Memorandum

FROM: Jeffrey F. Williamson, Ph.D., acting Chair
ACMUI Dose Reconstruction Subcommittee

DATE: April 29, 2004

SUBJECT: Report to ACMUI

Effective half life and Reconstructed distance of bedside readings

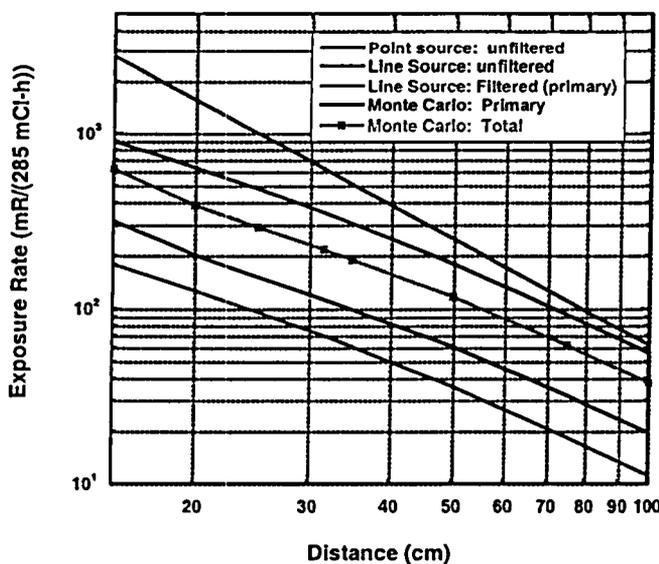
The more complete data consistently reveal $\lambda = 0.212 \text{ da}^{-1}$, equivalent to a half-life of 3.26 days. Based on Monte Carlo simulations, the patient-to-detector center distance best accounting for the measurements is about 20 cm. This suggests readings were taken with detector a few cm from lateral surface of the patient. Monte Carlo simulation is warranted in this particular case because the patient was known to have impaired renal function and because the fraction of thyroid uptake is typically small in metastatic thyroid cancer patients. This assumptions warrants treating the patient as a cylindrical volume source in which radioactivity is uniformly distributed.

Since a typical hospital bed is about 37 inches wide, the mattress edge-to-patient center is about 47 cm. Assuming that the daughter placed her forearms on the lateral aspect of the mattress edge, a distance of 37 cm would seem to be the shortest distance between the daughter's forearms and the patient center that could be maintained for a long period of time. Hence, DRS suggests that 37 cm is a more appropriate distance to apply to the Region III scenario rather than the estimated 20 cm measurement distance. Based on the ratio of MC air-kerma rates at 35 cm and 20 cm, it

is reasonable to scale the bedside readings downward by a 0.65 factor.
